DELAURENTIS - VACANT LOT - 21 NETHERMONT AVE NEW HOUSE CONSTRUCTION - TAX ID: SECTION 122.16-BLOCK 4- LOT 41

Re: 21 Nethermont Ave - Section, Block & Lot: 122.16/4/41 – Response to RPRC Determination Letter

After attending a meeting with the RPRC, we have been referred to the Planning Board to discuss the subject project further. Below are responses to the questions/comments from the RPRC Determination Letter dated 10/06/2020:

SHEET 1 of 6

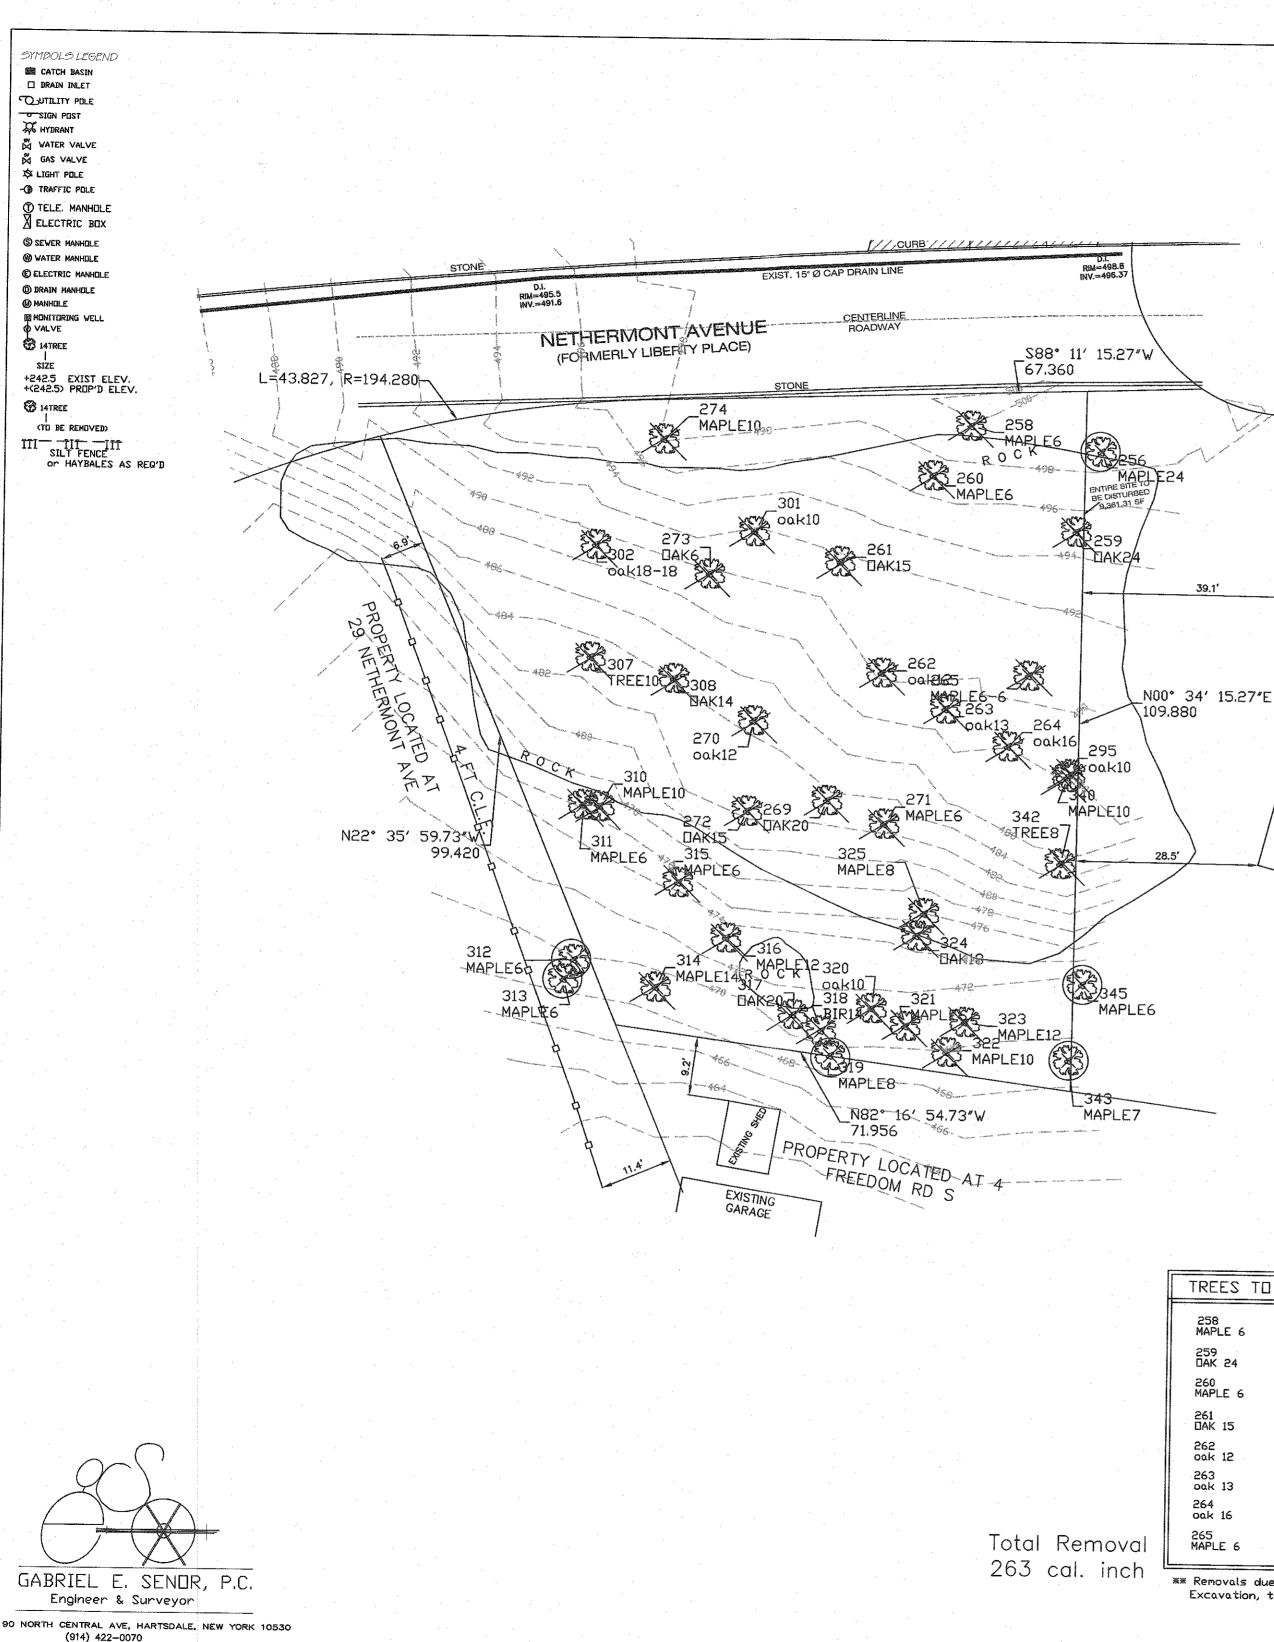
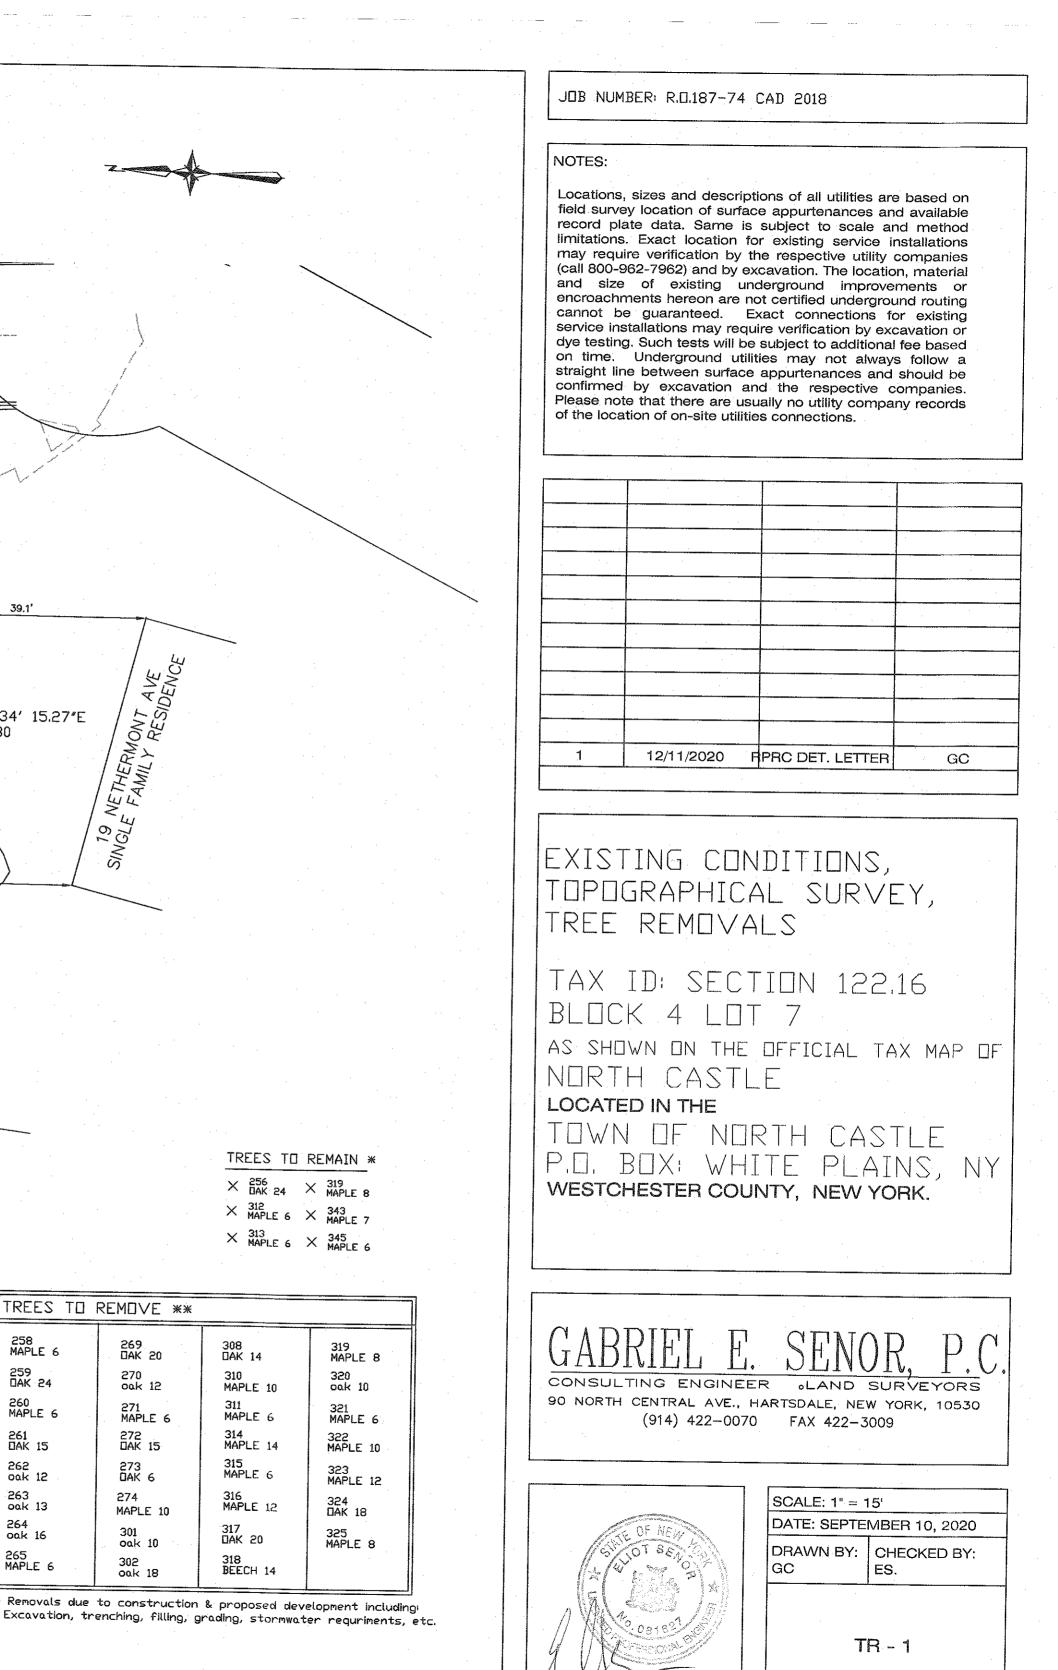
- The site plan should be revised to depict the location of all Town-regulated trees. In addition, the plan should depict all trees proposed to remain as well as depict (and quantify) trees proposed to be removed.

- See GABRIEL E SENOR P.C. Site Plan Package Existing Conditions, Topographical Survey, Tree Removals Plan Sheet 1 of 6, TR-1.
- Pursuant to Section 308-15.A(11) of the Town Code, the Applicant should prepare a plan detailing the replacement proposed to mitigate impacts from the proposed tree removal.

SCALE: 1"	SCALE: 1" = 15'			
DATE: SEI	DATE: SEPTEMBER 10, 2020			
DRAWN E GC	BY:	CHECKED BY: ES.		
	T	S - 1		
		SHEET 2 of 6

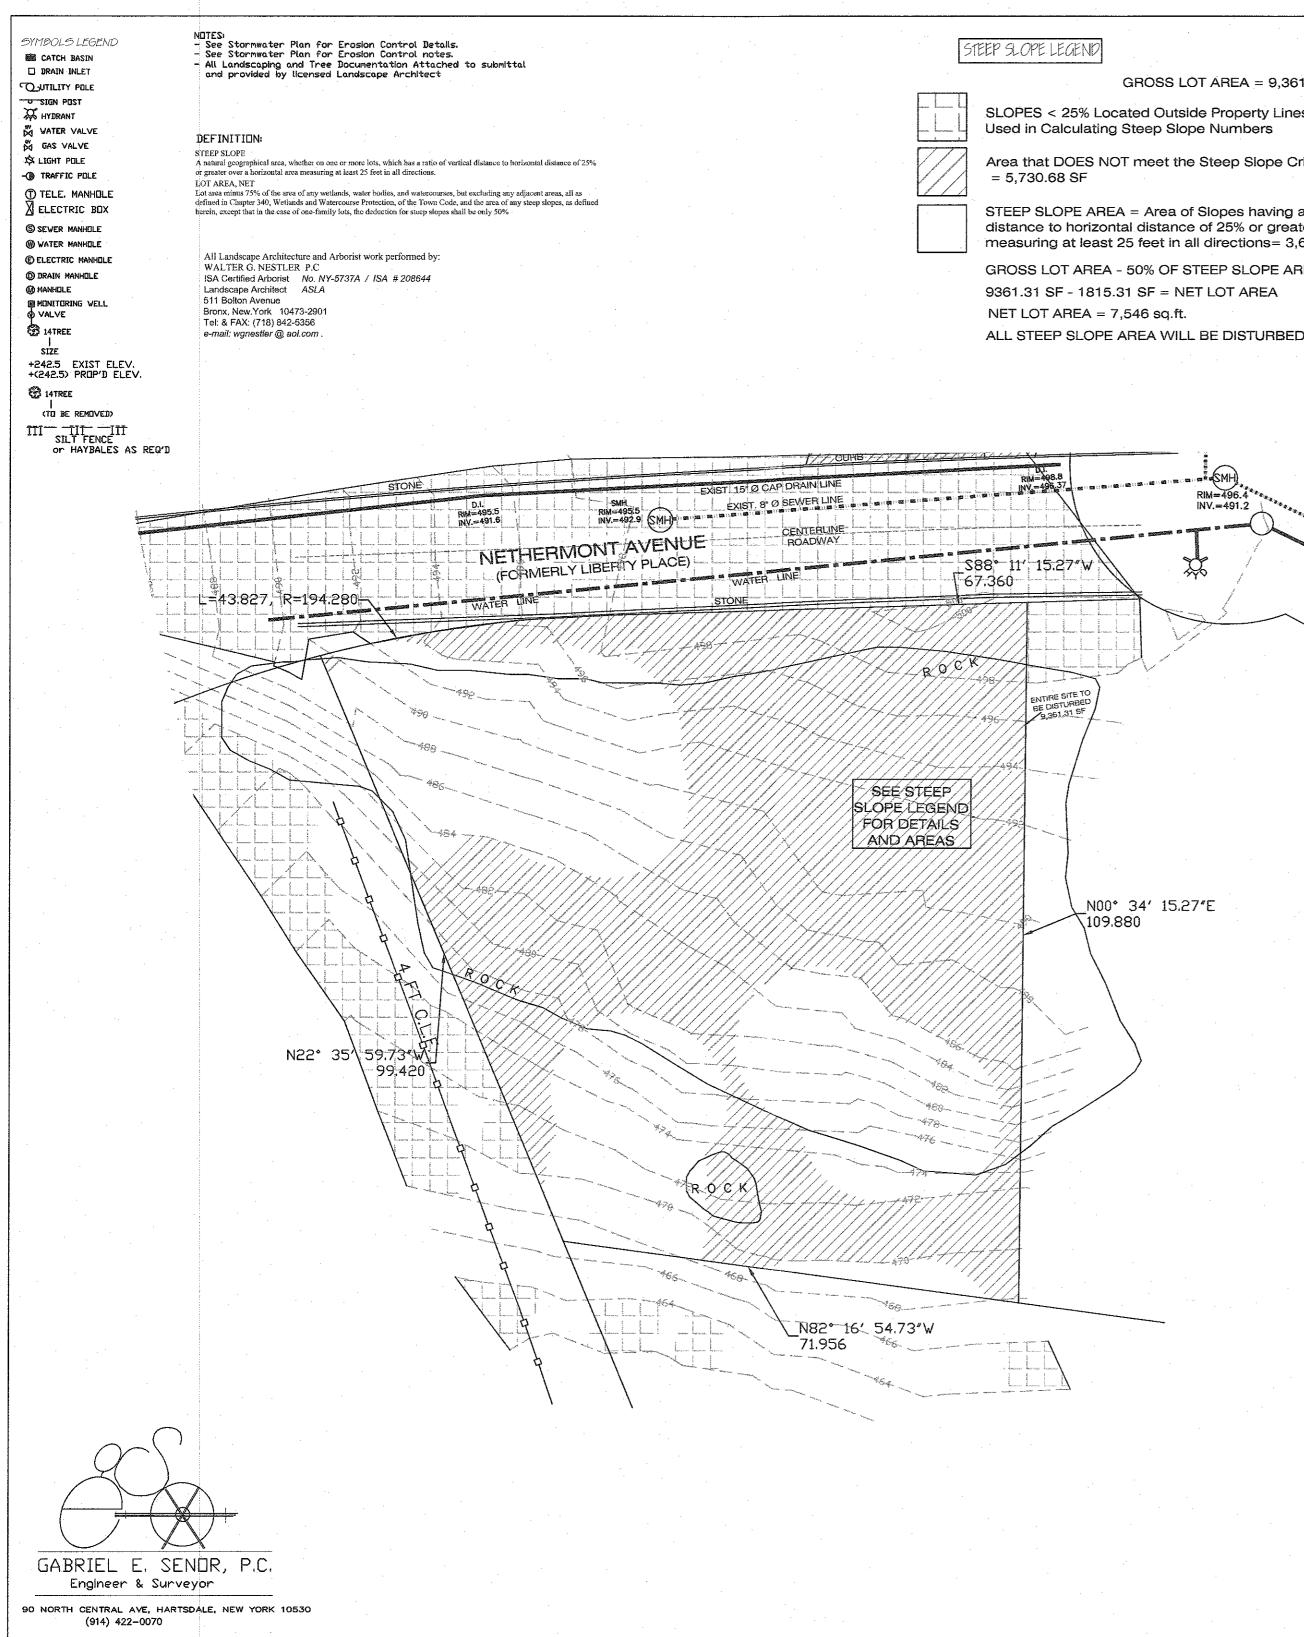
- See Landscape Architect Plan Package **Planting Plan** by Walter G. Nestler P.C. Dated 10/10/2020.
- The site plan should be revised to depict Town-regulated steep slopes. The plan should also depict (and quantify in square feet) the total proposed amount of Town-regulated steep slope disturbance.

- See GABRIEL E SENOR P.C. Site Plan Package Steep Slope Analysis sheet 2 of 6, TS-1 where all steep slope areas and disturbance within the steep slope areas are clearly shown.
